Proposal #02: 1016-05-64
Mauston – Wisconsin Dells
24th Avenue Structure B-29-24
IH 90
Juneau County

1016-05-66
Mauston – Wisconsin Dells
Koval Rd Bridges B-29-21 & B-29-22
IH 90
Juneau County

This is Addendum No. 01, which provides for the following:

Addendum No. 01
ID 1016-05-66
Revised Sheet 39
March 2, 2022

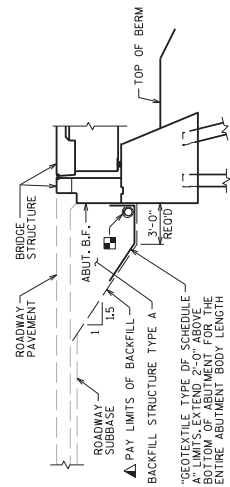
Revised Plan Sheets – 1016-05-66	
Plan Sheet	Plan Sheet Title (brief description of changes to sheet)
38-39	Added Removing Structure Item
48-49	Added Removing Structure Item

BID ITEM NUMBER	BID ITEMS	UNIT	SUPER.	NORTH ABUT.	PIER 1	PIER 2	SOUTH ABUT.	TOTALS
203.0220	REMOVING STRUCTURE B-29-21	EACH						1
206.0000	EXCAVATION FOR STRUCTURES BRIDGES B-29-21	LS						1

Addendum No. 01
ID 1016-05-66
Revised Sheet 49
March 2, 2022

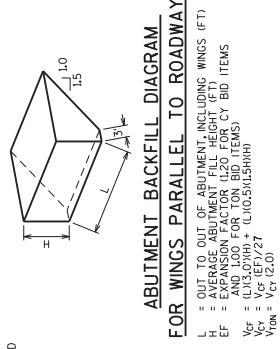
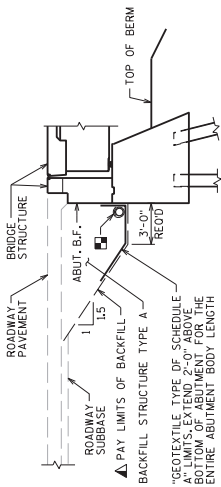
BID ITEM NUMBER	BID ITEMS	UNIT	SUPER.	NORTH ABUT.	PIER 1	PIER 2	SOUTH ABUT.	TOTALS
203.0220	REMOVING STRUCTURE B-29-22	EACH	---	---	---	---	---	1
206.0000	EXCAVATION FOR STRUCTURES BRIDGES B-29-22	LS	---	---	---	---	---	---
